## **Technical Memorandum**

### **Background Uranium Concentration**

#### **Homestake Millsite, Grants New Mexico**

Prepared for: Bluewater Valley Downstream Alliance and Multicultural Alliance for a Safe Environment

Figure 7: Uranium concentrations for the far-upgradient alluvial wells. Source of data: Homestake digital groundwater chemistry database

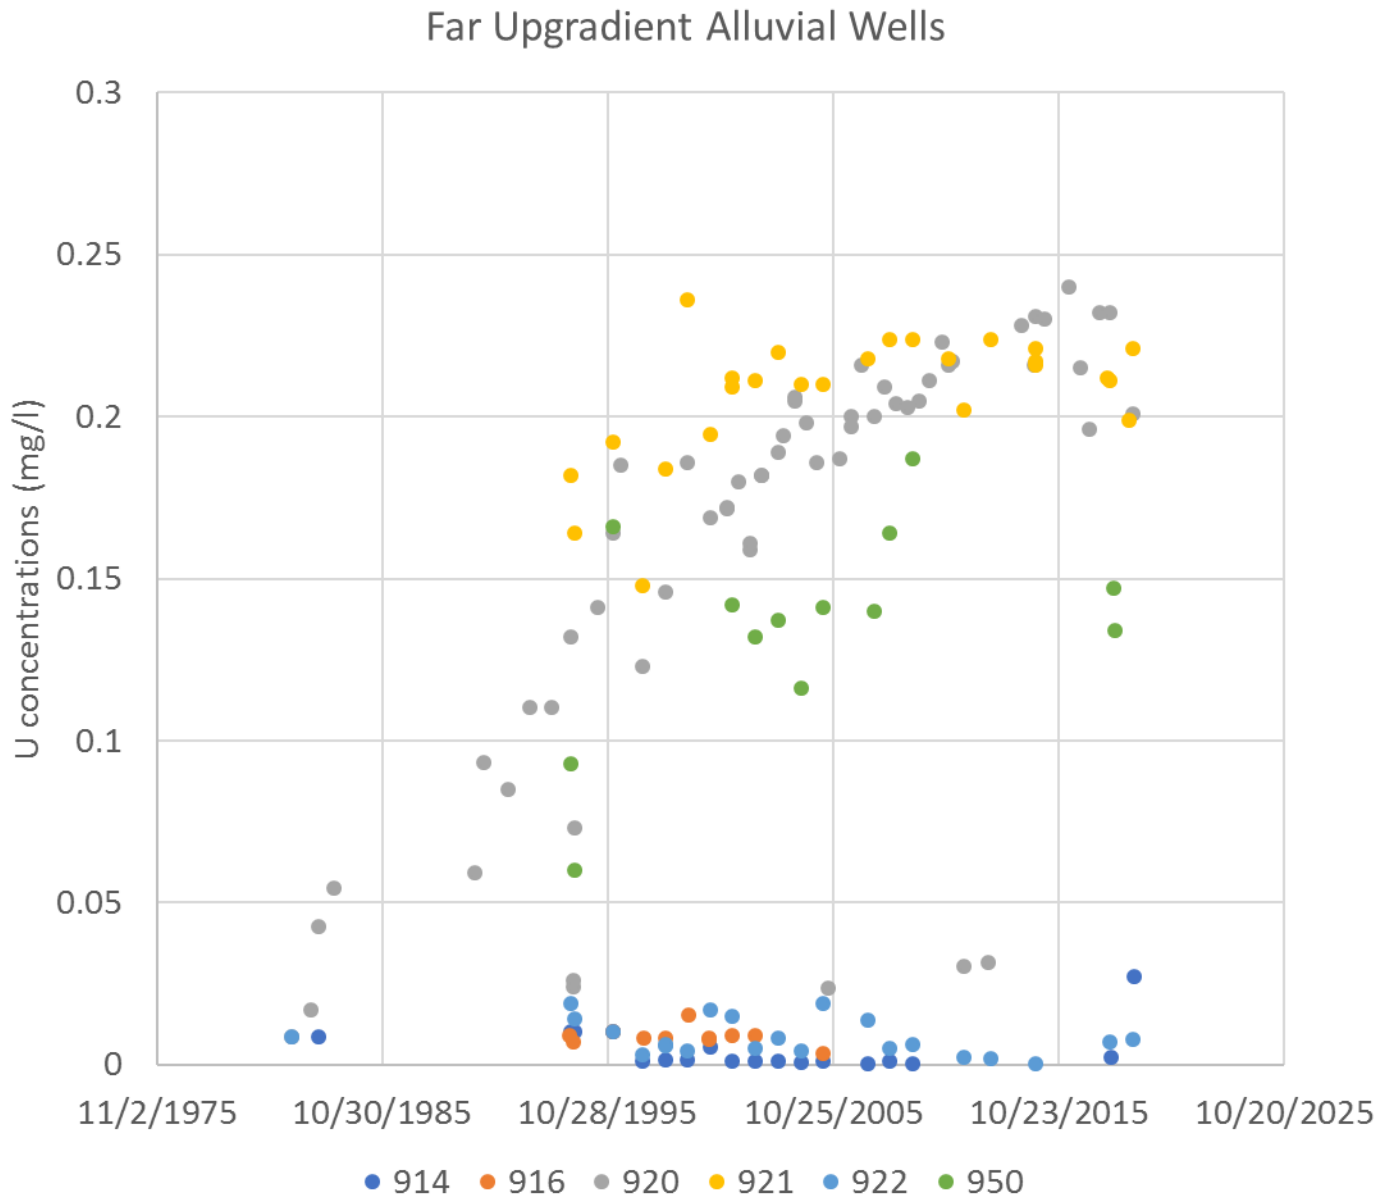
U concentrations at the far-upgradient wells trend upward which reflects the downstream advection of U from upstream millsites (Figure 7). None have 1970s data, but the earliest observations are less than 0.05 mg/l. Wells 920, 921 and 950 show a distinct upward U concentration trend that does not occur at wells 914 and 922, which lie east and west, respectively, of the other wells. U concentrations at well 916 which begin in the early 1990s are very low whereas concentrations at 921 exceeded 0.15 mg/l. U concentrations at the far-upgradient wells were low, less than 0.03 mg/l, prior to discharge from upstream mines and mills reaching the area.

Figure 8: Uranium concentrations for the near-upgradient alluvial wells. Source of data: Homestake digital groundwater chemistry database

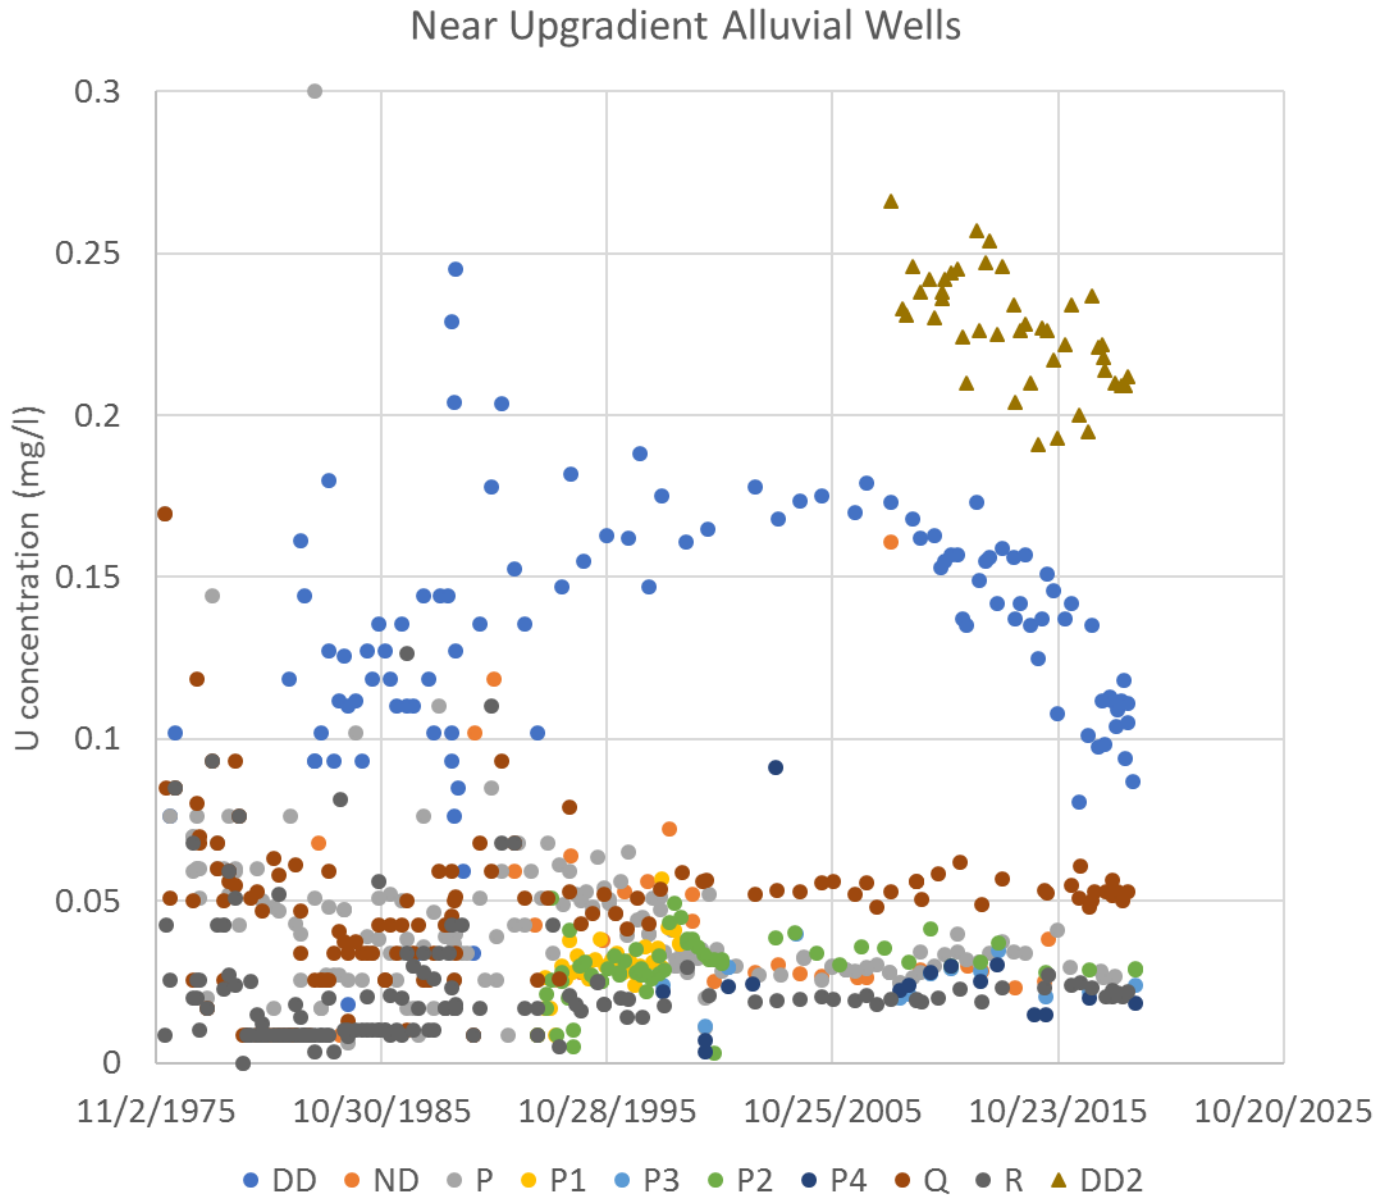
U concentrations at the near-upgradient wells support Myers (2015) hypothesis that U advection from the LTP caused occasional high U concentrations or spikes in many of the wells between 1975 and about 1985 (Figure 8). After 1985 the concentrations generally decreased to less than 0.06 mg/l, with well DD being an exception. Concentrations at well DD reflect a different source related to U transport that has primarily occurred west of the LTP. Well D2, which was not used for the determination of background U concentrations but lies in the high-U pathway (Figure 4), has high concentrations subsequent to 2008.

HMC calculated background U concentrations using data from 1995 through 2004 for the near-upgradient wells. It is unknown whether these data represent pre-milling conditions because residual U from LTP mounding could be causing higher concentrations. There is no apparent trend that would reflect residual U slowly decreasing. Simply stated, it is not known whether 1995 through 2004 near-upgradient U concentrations are representative of background. However, trends in the paleochannel represented by DD and DD2 show that data from DD is not representative of background. DD at least shows that the western portion of the alluvium is affected by different flow sources than most of the alluvium. The trend at DD that shows significantly lower values in the 1970s shows that values observed at that well between 1995 and 2004 are not at all representative of background.

Figure 9: Comparison of water chemistry at well DD as compared with wells P, Q and R. Data source: HMC database

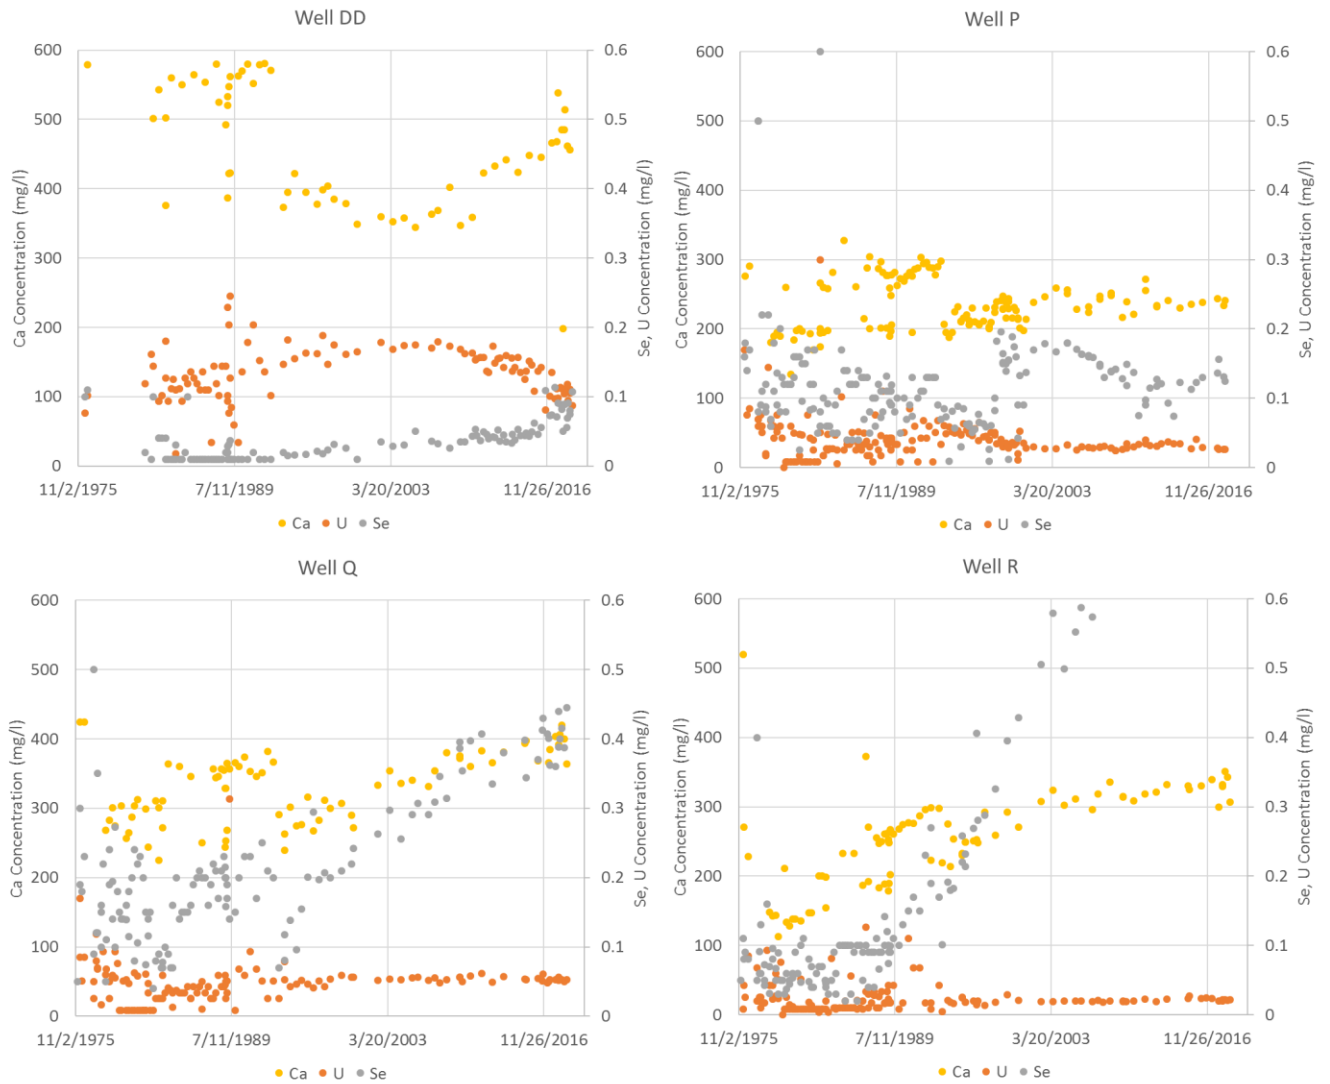
Water chemistry data for well DD compared to other background alluvial wells further demonstrates how unusual well DD is. While it has the highest U, it has the lowest Se and highest Ca values (Figure 9). These substantial differences support a hypothesis that the water at well DD originated from a different

Figure 10: Percent exceedance plot for the near upgradient wells from 1995 through 2004, with and without well DD. Data source: HMC database

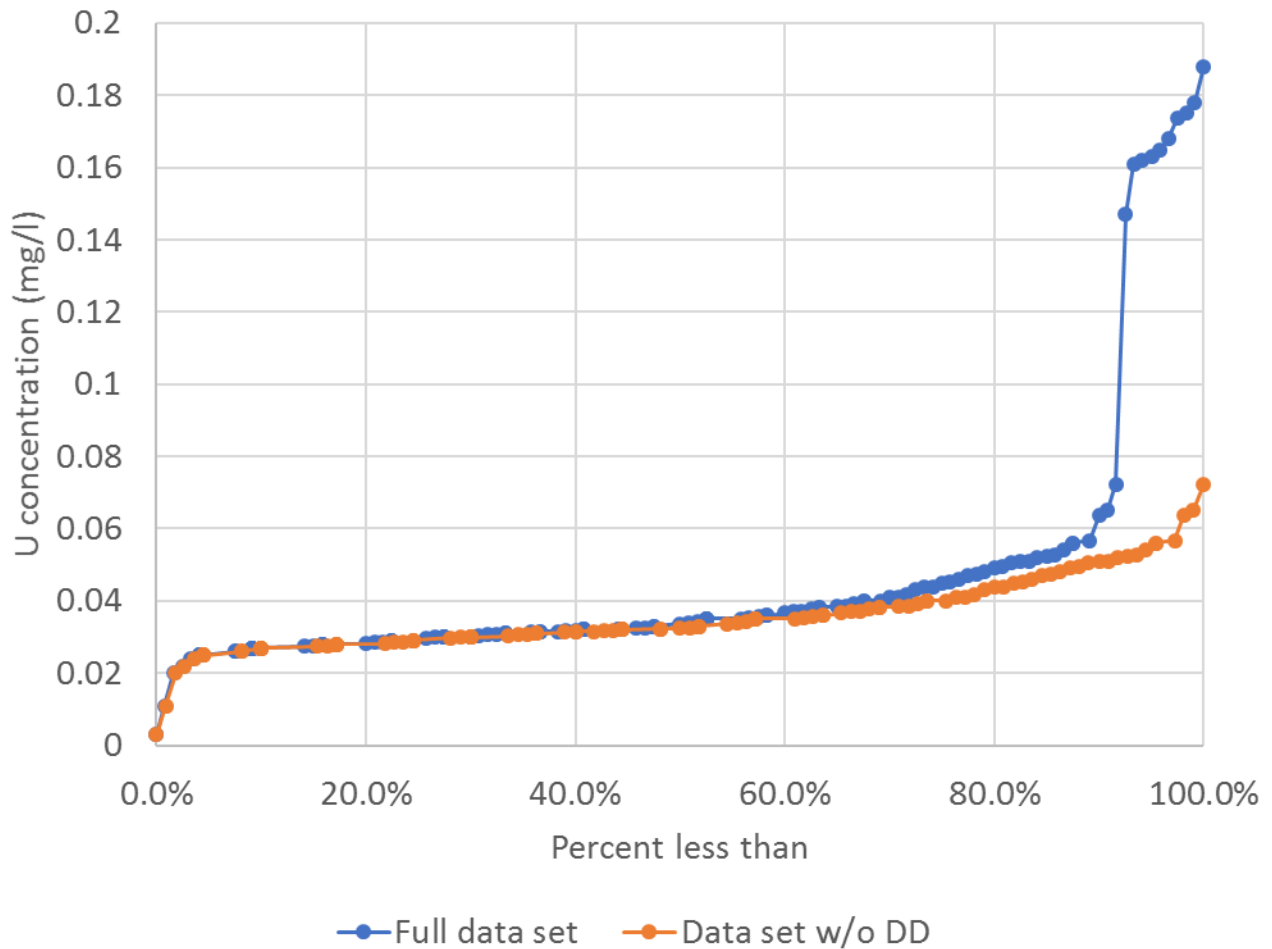
Frequency plots of the near-upgradient well data for 1995 through 2004 show the major effect on calculated background caused by well DD (Figure 10). With DD data, the 95% exceedance is about 0.16 mg/l which corresponds to the Homestake-estimated background, but without DD, it is about .054 mg/l. The higher U values occur at well Q which exhibits relatively stable values around 0.05 mg/l after some fluctuation prior to 1985 (Figure 8). The median value for each is about 0.03 mg/l.

A reasonable background value for U in the alluvium is 0.04 mg/l based on three factors. The 95% exceedance value at the near upgradient wells without well DD is 0.05 mg/l. However, the far upgradient wells and wells southwest of the LTP commenced at concentrations less than 0.03 mg/l but there are few observations from either point. Due to the limited number of observations, it is difficult to include this data in a frequency distribution using near upgradient wells for which there are many observations. Statistics based on many observations at some wells and few at others are controlled by the wells with many observations. Therefore, I adjusted the 95% value determined using statistics for the near upgradient wells to a recommended background equal to 0.04 mg/l.

Figure 12: Uranium concentrations for the Upper Chinle zone wells. Observations for well CW3 that are higher than 0.2 mg/l, some as high as 3.0 mg/l, after 2002, are not shown. Source of data: Homestake digital groundwater chemistry database

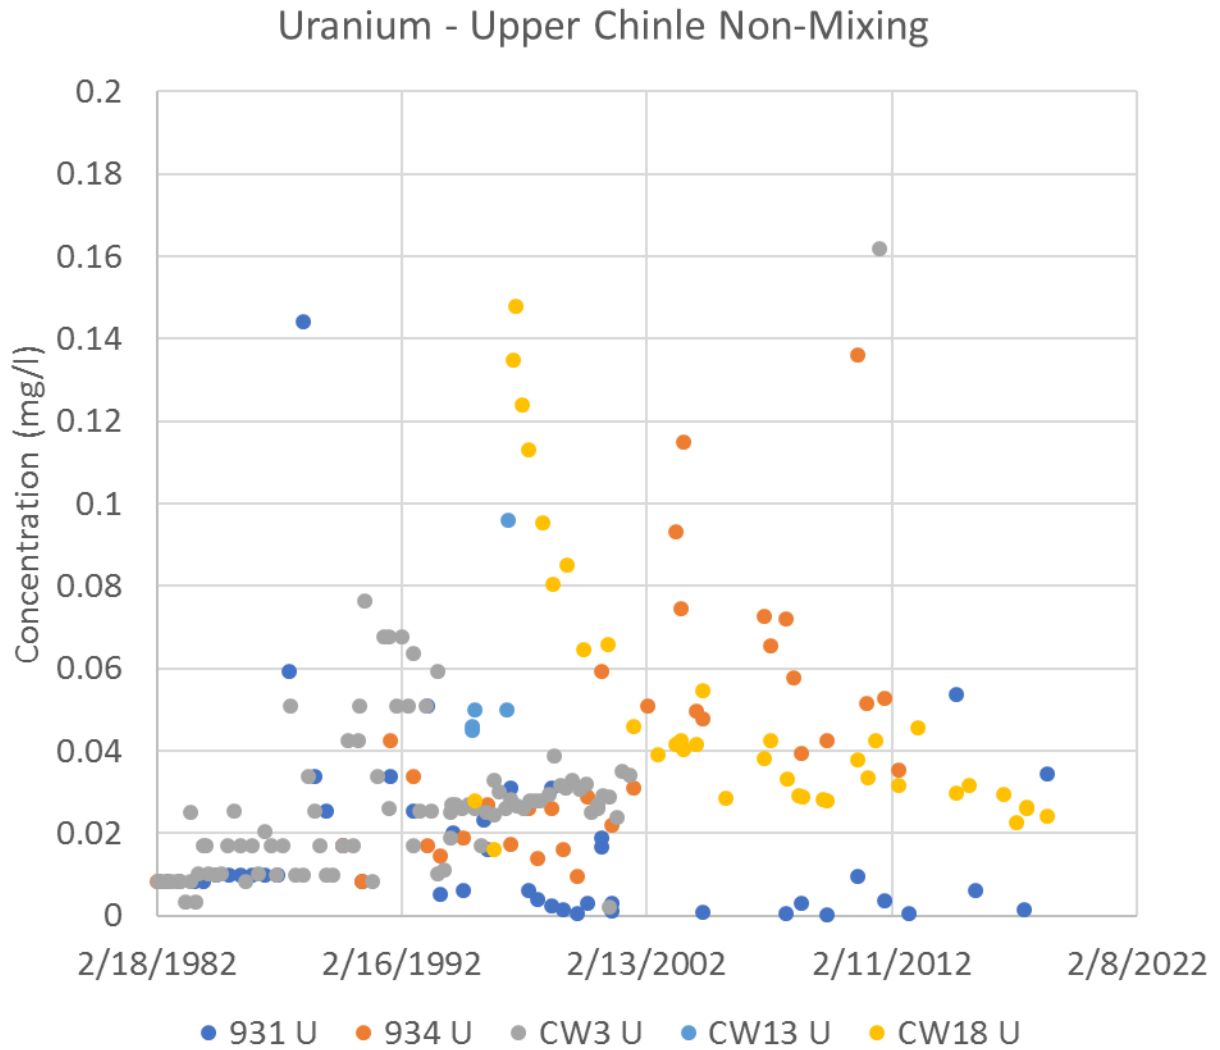
Prior to 1987, all Upper Chinle HMC background well concentrations are less than 0.04 mg/l (Figure 12). Between 1987 and the early 1990s, there was a rapid increase up to close to 0.1 mg/l. Starting around 2003, one well, CW3, increased to as much as 3 mg/l. All Upper Chinle monitoring wells show influence from millsite alluvial uranium starting around 1985 (Figure 12). This is due to seepage from the LTP into the alluvium in the 1970s reaching the Chinle in the time it takes to reach the base of the alluvium.

Wells CW3 and 931, close to the northeast corner of the LTP and southeast of the LTP, have low concentrations prior to 1985 but then trend upward (Figure 12). These wells have low U concentrations early in the period because they are far from the subcrop. Measurements at well 934, further southeast of the LTP, started a few years later at concentrations similar to CW3 and 931. CW18 concentrations started at over 0.14 mg/l and dropped through the years as cleaner water entered the aquifer.

U concentrations for wells CW3 and 931, which are apart from the East Fault and the subcrop, are least affected by tailings seepage and therefore are most likely to represent natural background. A reasonable background for the Upper Chinle non-mixing zone is 0.03 mg/l based on concentration data prior to 1987 at CW3 and 931.

Figure 15: Uranium concentrations for the HMC Middle Chinle non-mixing zone wells. Source of data: Homestake digital groundwater chemistry database

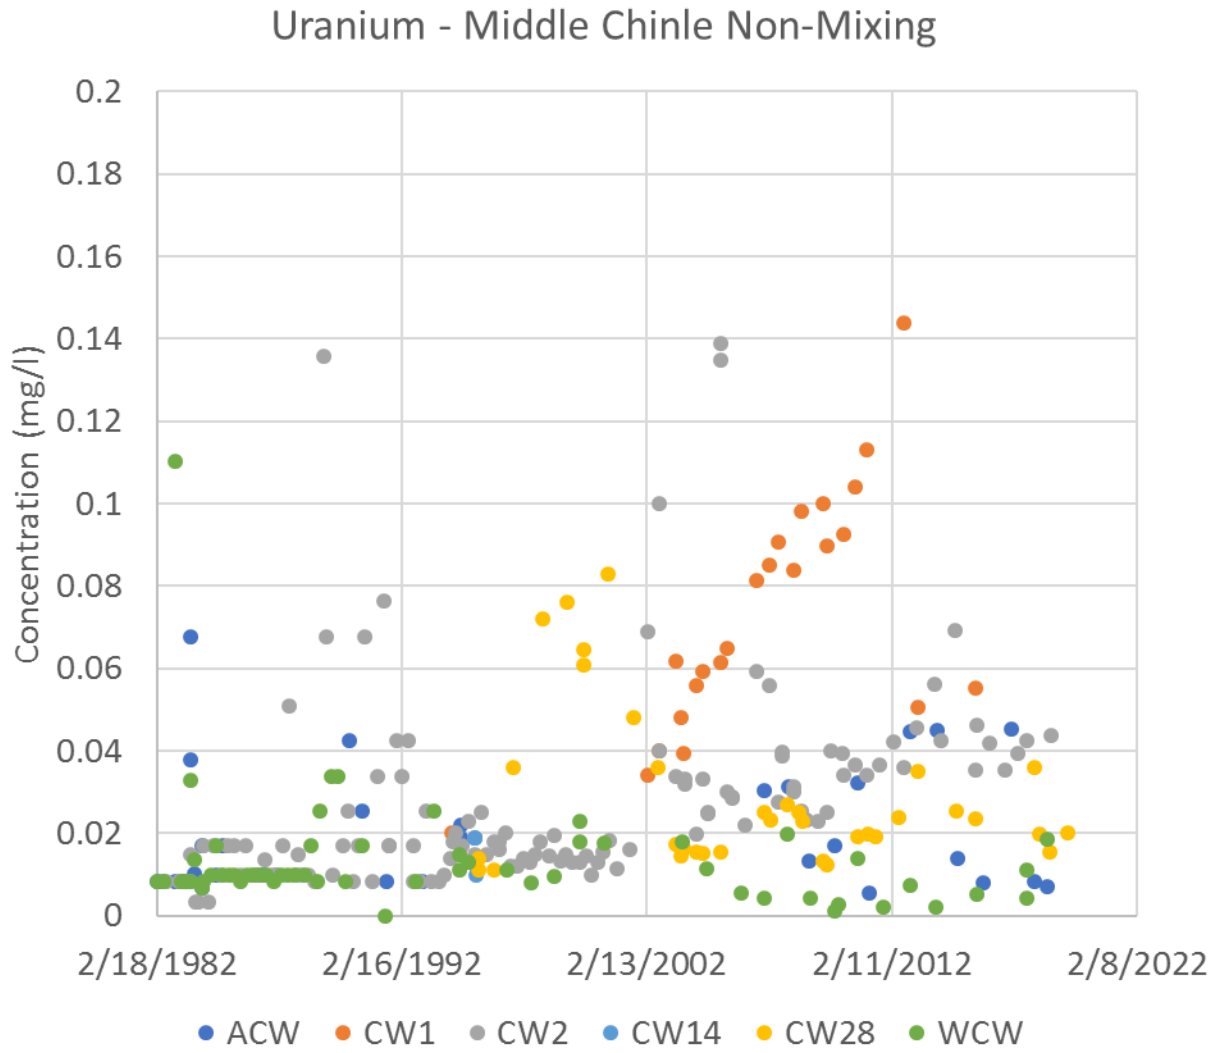
Most U concentrations at four Middle Chinle nonmixing wells south of the LTP are less than 0.05 mg/l (Figure 15). The exceptions are five observations at CW28 between 1997 and 2000 and one observation at ACW and WCW during 1982 and 1983. U concentrations at CW1 and CW2, which are just north of the LTP (Figure 14), trended up with time, showing a clear effect of leakage from the LTP which could have reached the Middle Chinle without passing through a mixing zone but by seeping through the Middle Fault (fault shown on Figure 2 but not on Figure 14).

Middle Chinle well data from 1982 through 2002, not including CW1 and CW2, has a 95% exceedance of about 0.068 mg/l. If the five anomalous data points at CW28 are removed, the 95% exceedance would be about 0.05 mg/l and if the 1982 and 1983 points are removed, it would be close to 0.04 mg/l. The median value is 0.01 mg/l due to many non-detects. Since 2002, all data other than from CW1 and CW2 are less than 0.035 mg/l excepting three data points at ACW which are a little higher than 0.04 mg/l. U concentrations in the Middle Chinle nonmixing zone have decreased with time which indicates that removing the anthropogenic source allows the aquifer to return to its natural background. This would not likely have occurred if natural factors worked to keep the U concentrations high.

A fair background level for the nonmixing zone Middle Chinle aquifer would be 0.04 mg/l, based on frequency analysis of HMC's Middle Chinle well data from 1982 through 2002 excepting wells and observations described above. It also accounts for the many Middle Chinle wells in the three subdivisions with very low concentrations early in the period by using a lower estimate even though the data is not amenable to being added to the frequency analysis. Using this data accounts for the fact that U concentrations are variable, but most were initially very low. Higher U in the Middle Chinle that occurred subsequent to low concentrations resulted from contamination in the alluvium and should not be considered background.
